Access Compliance Report

Public Rights-of-Way

Intersection ID: 19024	Main Street: CAVENDISH_CT	Cross Street: PROVIDENCE_RD	Location: SE
ADA ID: 4BE28461FFCF	Ramp Type: PerpDiag	Initial Pass/Fail: Fail	Overall Compliance: No
		Severity Score: 8.75

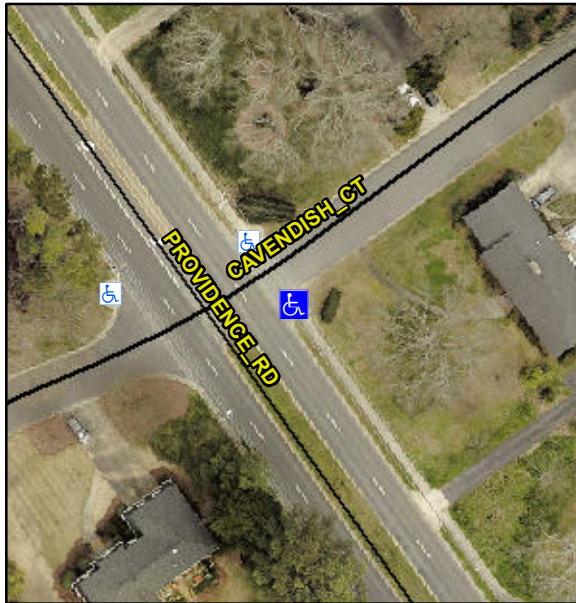
Not Found, R304.5.1

Compliance	Description	Data	Compliance	Description	Data
N/A	Ramp Length (in)	48.0	Yes	Ramp Slope (%)	6.7
No	Ramp Width (in)	39.0	Yes	Ramp XSlope (%)	0.0
N/A	Flare Type LT	N/A	N/A	Flare Type RT	N/A
N/A	Flare Slope LT (%)	N/A	N/A	Flare Slope RT (%)	N/A
N/A	Flare Traversable LT?	N/A	N/A	Flare Traversable RT?	N/A
N/A	Landing Length (in)	N/A	N/A	DWS Provided?	N/A
N/A	Landing Width (in)	N/A	N/A	DWS Contrast?	N/A
N/A	Landing Slope (%)	N/A	N/A	DWS Length (in)	N/A
N/A	Landing X Slope (%)	N/A	N/A	DWS Full Width?	N/A
N/A	Landing Curb? (Y/N)	N/A	N/A	DWS Offset (in)	N/A
N/A	Shared Landing?	N/A			
N/A	Gutter Ponding?	N/A	N/A	Gutter Slope (%)	N/A
N/A	Gutter Lip Ht (in)	N/A	N/A	Gutter X Slope (%)	N/A
N/A	Painted X Walk1?	No	N/A	Painted X Walk2?	No
	X Walk 1 Direction	To NW		X Walk 2 Direction	To SW
N/A	X Walk 1 Width (in)	N/A	N/A	X Walk 2 Width (in)	N/A
	X Walk 1 Slope (%)	5.3		X Walk 2 Slope (%)	3.0
	X Walk 1 X Slope (%)	1.1		X Walk 2 X Slope (%)	4.3

Remove & Replace Curb Ramp With Two New Directional Ramps or Equivalent.
